Migrating from the LAN9115 to the LAN9215

1 Objective

This purpose of this application note is to assist SMSC customers with existing LAN9115 designs when upgrading to the new LAN9215 device. This upgrade is straightforward. The LAN9215 does require a simple PCB change, which is required to support the HP Auto-MDIX PHY (even if this mode is not used). This application note addresses all the differences between the LAN9115 and the LAN9215 devices, making this transition as easy as possible.

Figure 2.1 Transmit Circuit

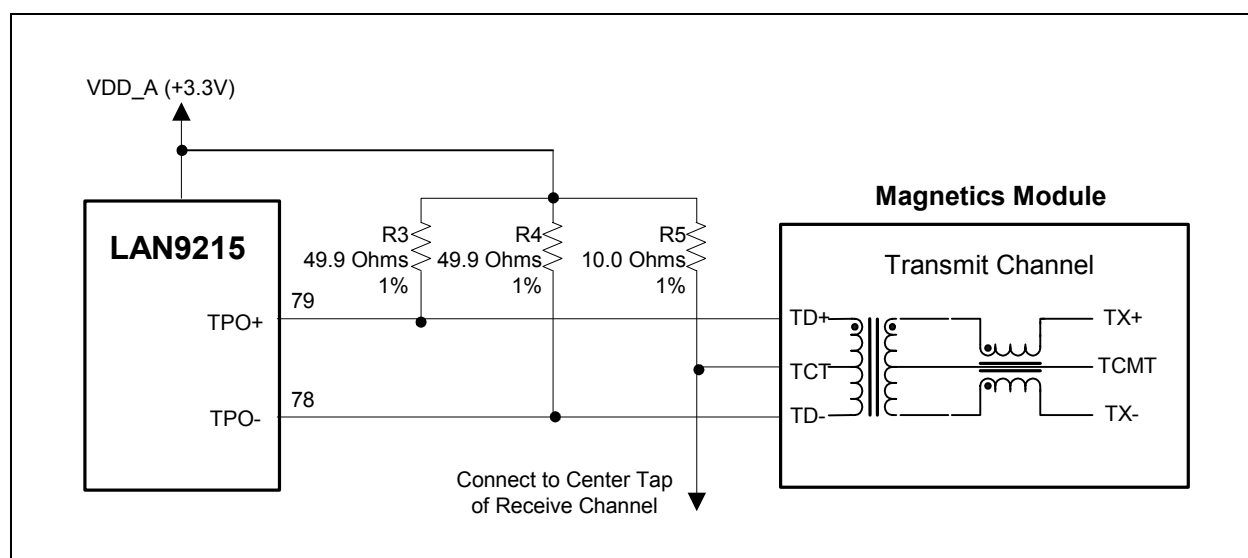
There are only two differences between the transmit circuit for the LAN9215 and the one previously used for the LAN9115:

- The LAN9215 uses magnetics that support HP Auto-MDIX.
- The device-side center tap of the transmit core (TCT) is attached to the device-side center-tap of the receive (RCT)

- A 49.9 ohm, 1% resistor from each side of the twisted pair to VDD_A (+3.3V)
- A 10 ohm, 1% resistor from the transmit center tap to VDD_A (+3.3V).

Figure 2.2 Receive Circuit

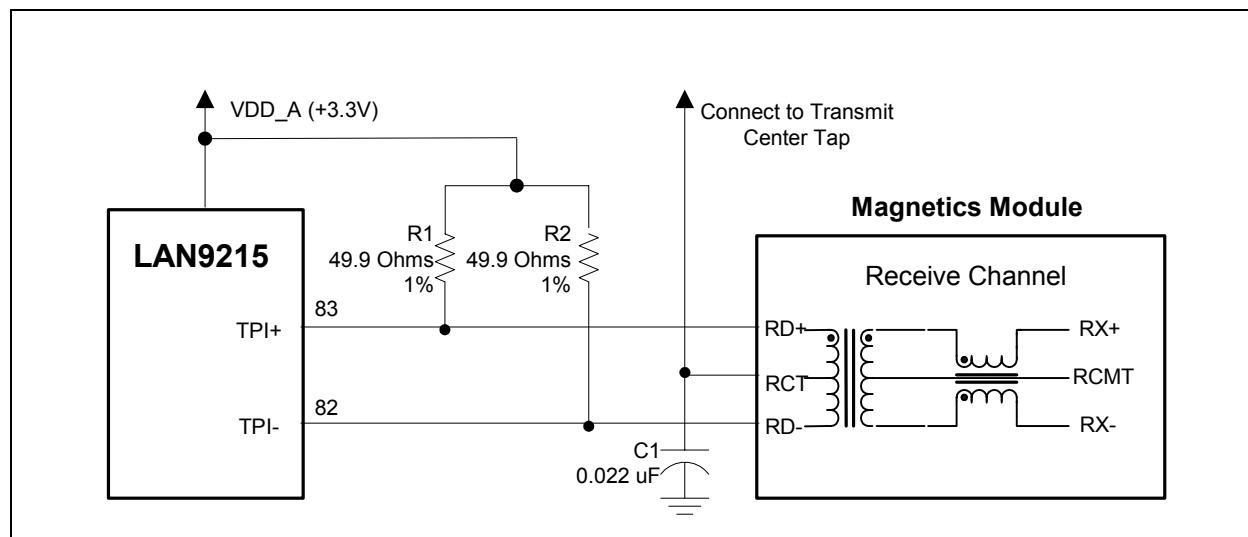
The differences between the LAN9215 and the LAN9115 are as follows:

- The LAN9115 had two 6.8nf capacitors, one in series with each side of the twisted pair, in the LAN9215 these are eliminated (shorted).
- In the LAN9115, the mid-point between the two 49.9 ohm resistors is tied to the center tap of the magnetics (RCT) and to a .01uF bypass capacitor to ground. In the LAN9215, both resistors are tied to VDD_A (+3.3V). The .01uF bypass capacitor is eliminated. The center-tap of the receive channel of the magnetics is tied to the transmit center tap (TCT) and to a common 0.022uF bypass capacitor to ground.
